PROPOSAL REQUEST

PROJECT: Williamson County Sheriff's Office Training Center
8160 Chandler Road
Hutto, TX 78634

PROPOSAL REQUEST NO: 26

Description: Incorporate the following revisions to the documents to incorporate AV changes from the AV coordination meeting.

LEGEND AND NOTES - AUDIO VISUAL

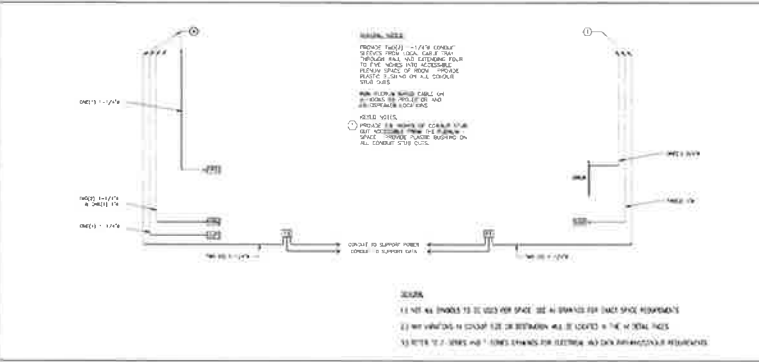
- Item No. 1. Sheet AV001 - LEGEND AND NOTES - AUDIO VISUAL
 - A. Added in-ceiling cameras (and infrastructure as needed) to the Audio Visual Devices. Active Equipment design to be provided by the AV Integrator as an "add".

FLOOR PLAN -
AUDIO VISUAL

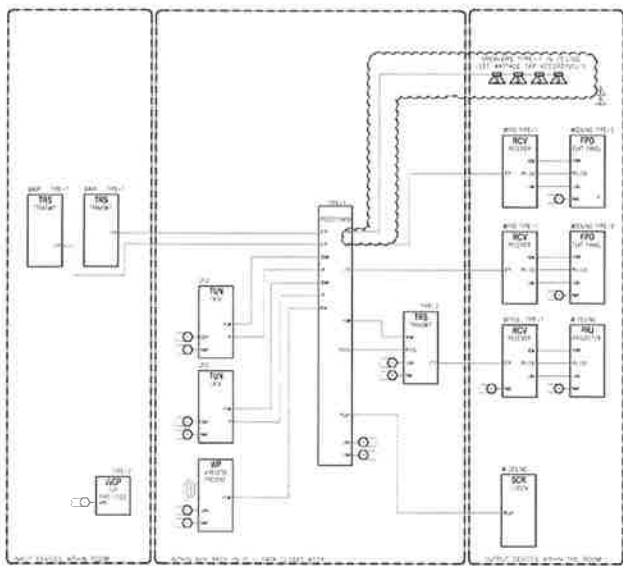
- Item No. 2. Sheet AV101 - FLOOR PLAN - AUDIO VISUAL
 - A. Added an AV Poke-Thru floor box to the lectern position in the Training Room #157.
 - B. Deleted the AVP location on north wall of Training Room #157.

BID ISSUE
AV402

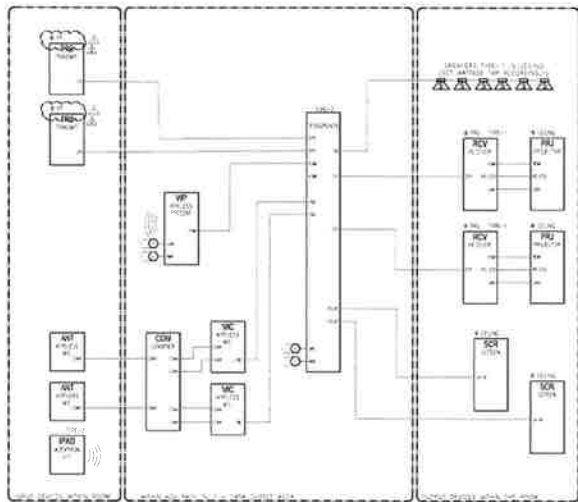
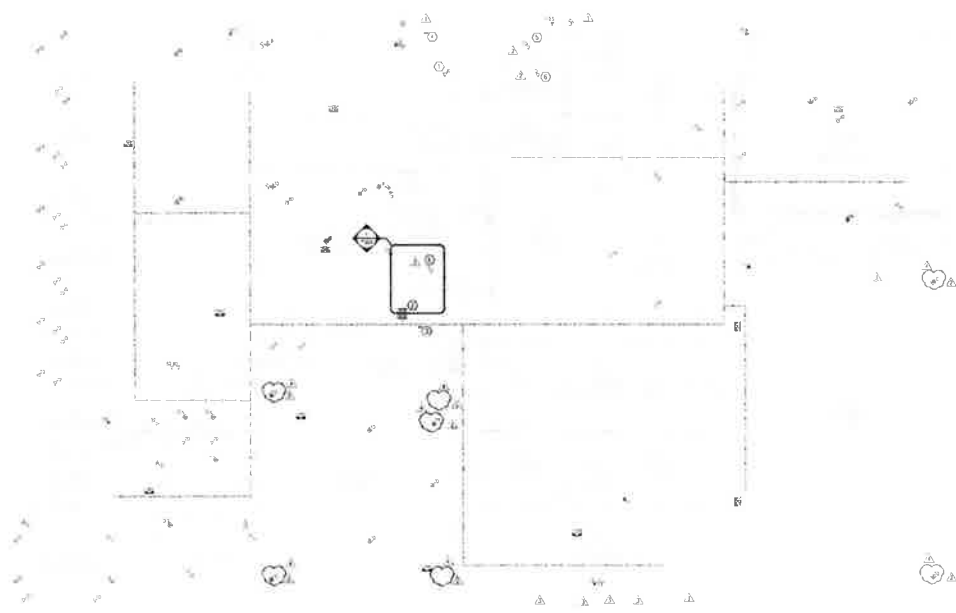
- A. Added four (4) in-ceiling speakers for audio reinforcement in the Operations Briefing room #121, 1-Line drawing.
 - B. Specified location of AV Transmitters (TRS) at Poke-Thru locations in Training Room #157, 1-Line drawing.

FLOOR PLAN - COMMUNICATIONS
DATE: 1/11/18

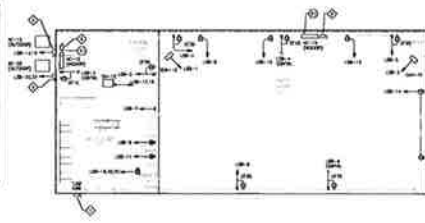
- Item No. 4. Sheet T101 - T101 FLOOR PLAN - COMMUNICATIONS
 - A. Added Data at AV Poke-Thru floor box to the lectern position in the Training Room #157.

- B. Added Data for two (2) in-ceiling cameras the Training Room #157.
 - C. Added Data for two (2) in-ceiling cameras in Defense Tactics #143.
- Item No. 5. Sheet AV402 - GENERAL DETAILS - AUDIO VISUAL

FLOOR PLAN - POWER

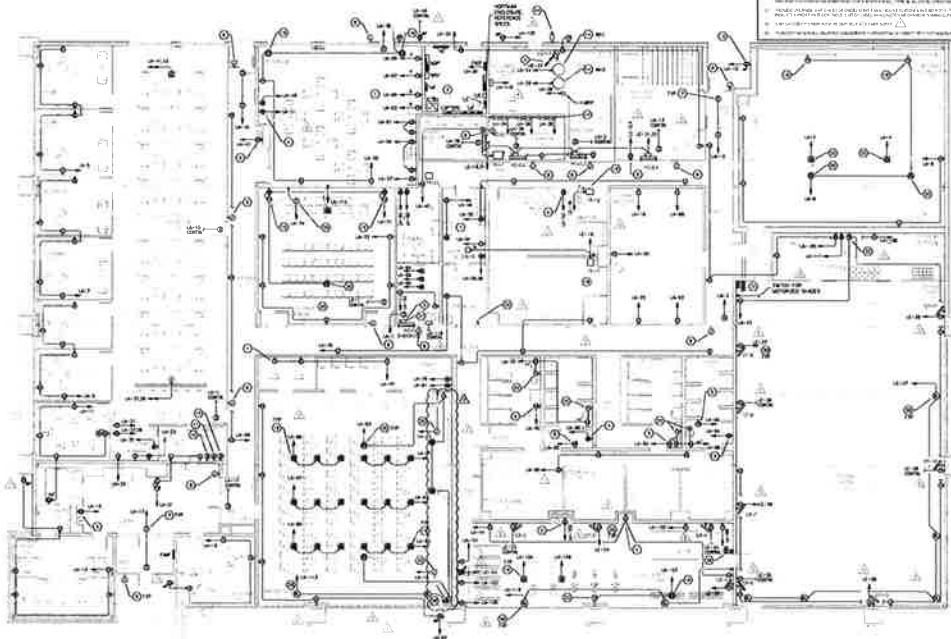
- Item No. 6. Sheet E311 - FLOOR PLAN - POWER
 - A. Relocate wall switches and wall outlets in Training Room #157.
